RE: Forest Street PUD (Hayden Pointe Ph. 4, 5, 6) – PUD Master Plan Update ID: 1820004201 & 1820004221 Single Family Development

Thank you and the Technical Review Committee for providing your time and expertise in providing us your comments for the Forest Street / Hayden Pointe Ph 4, 5, 6 project within the Town of Shallotte. Please see below our responses to the comments provided.

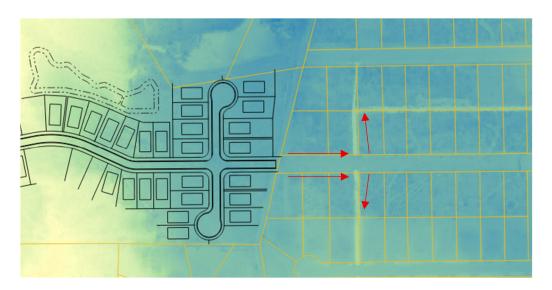
4. Will Road F physically connect to existing Pinecrest Road NW? If so, please assure existing drainage is considered.

Response- Connection expected as requested to existing roadway- the existing roadway drains through existing ditch networks and drains towards ditches located between lots within their community so minimal roadway drainage consideration is expedited (LIDAR information included below for preliminary informational purposes).
